**Amendments to the Drawings:**

Appl. No. 10/679,391  
Amdt. dated March 28, 2007  
Reply to Office Action of November 28, 2006

Attachment: Replacement Sheets  
Annotated Sheets Showing Changes

FIG. 1  
(CONVENTIONAL ART)

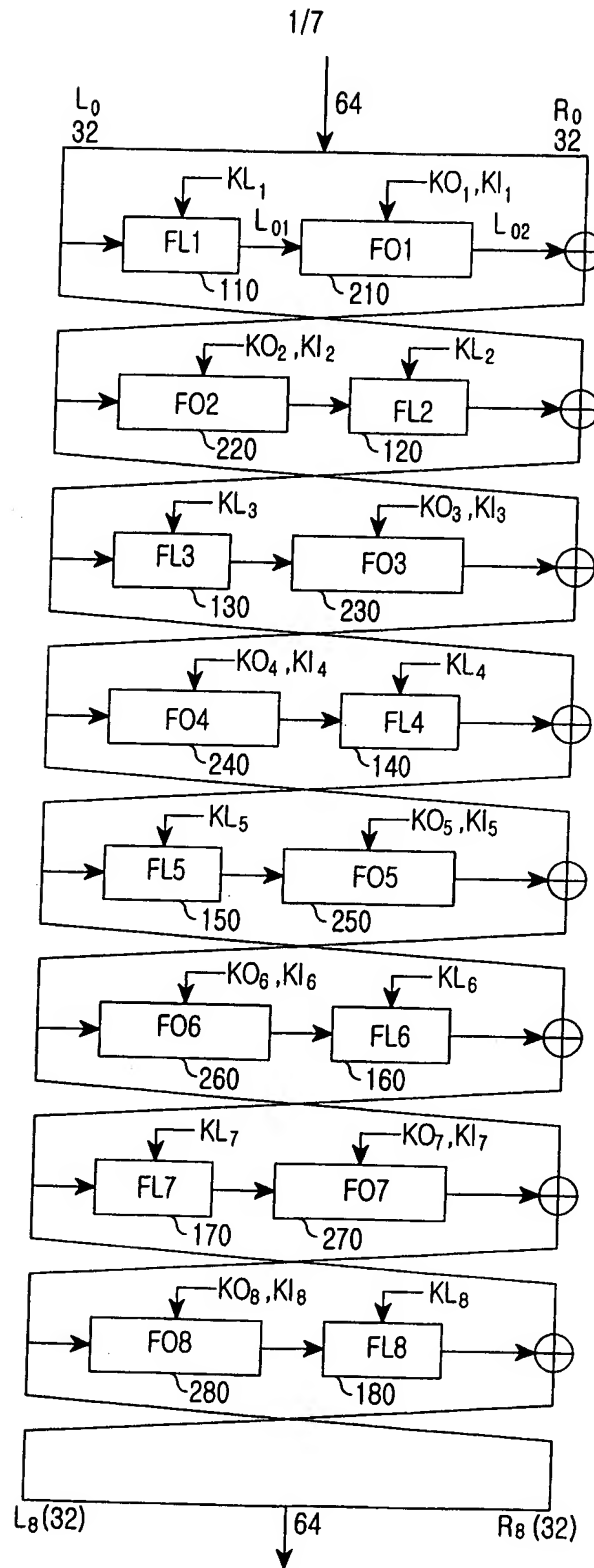
The Examiner objected to Figures 1, 2A, 2B and 3 because the figures should be designated by a legend such as --PRIOR ART--. To overcome the above objection, Applicant has added the legend -- (CONVENTIONAL ART) -- to Figures 1, 2A, 2B and 3.

FIG.3  
(CONVENTIONAL ART)

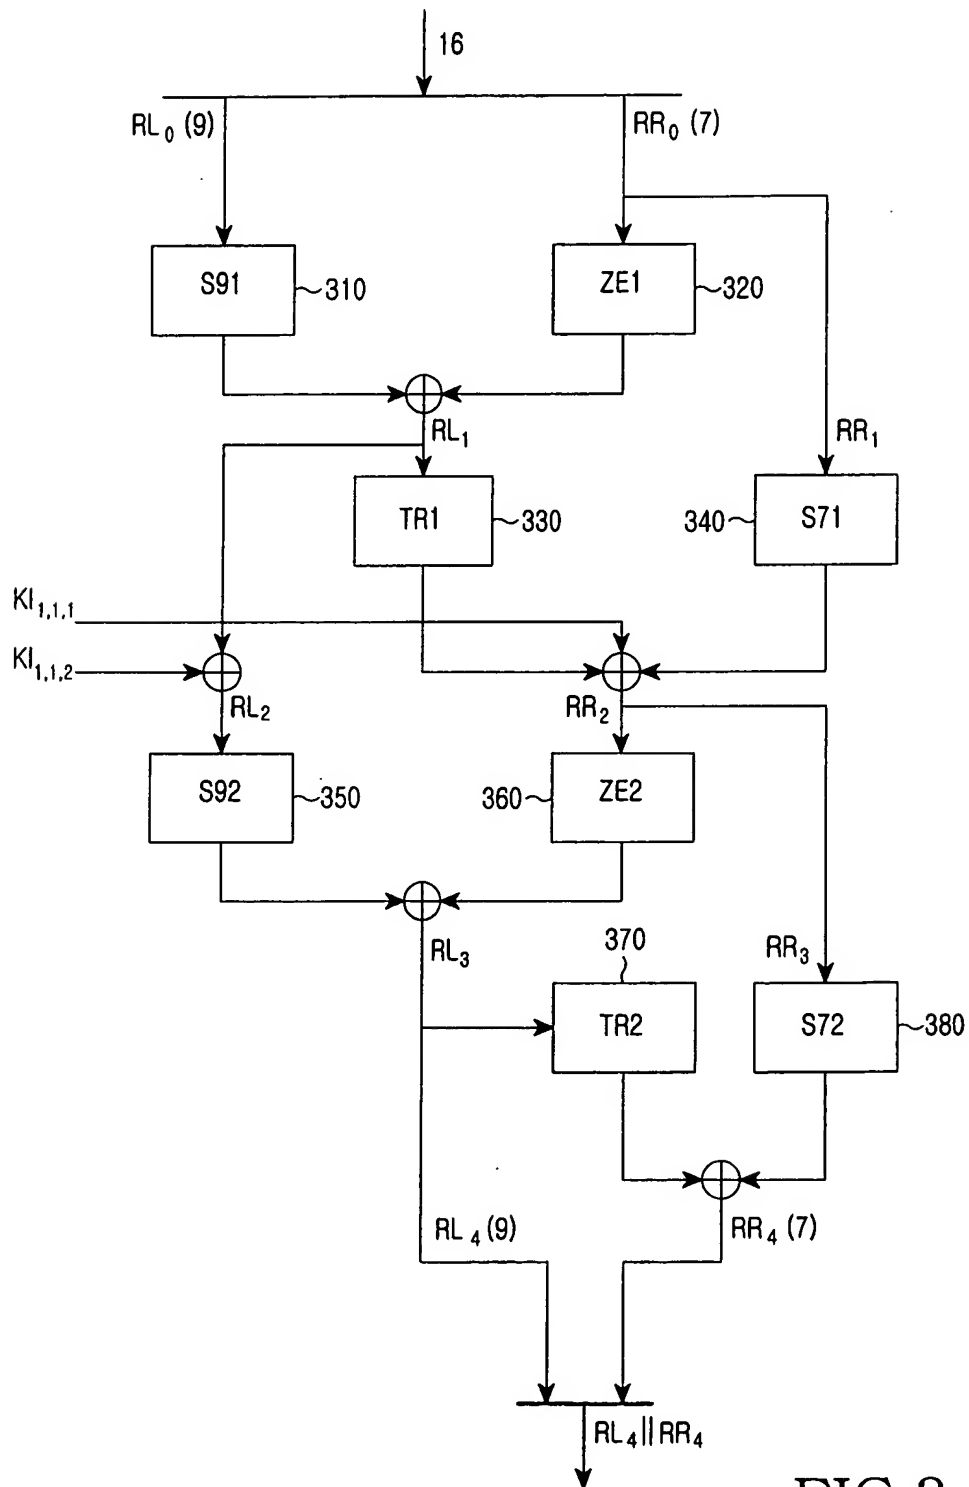
(c) Reference character "360" is used in FIG. 3 to

designate "ZE2 unit" but "FL<sub>2,3</sub>" in FIG. 5. The amendments to FIG. 5 above in (a) will overcome the Examiners objection to FIGs. 3 and 5.

(d) Reference character "360" is used to receive the signal

"RR<sub>1</sub>" in the specification (page 6, line 5) but "360" is used to receive the signal "RR<sub>2</sub>" in FIG. 3. To overcome the Examiner's objection to FIG. 3, Applicant has amended the specification on page 6, lines 5 and 6 to change "RR<sub>1</sub>" to --RR<sub>2</sub>--.
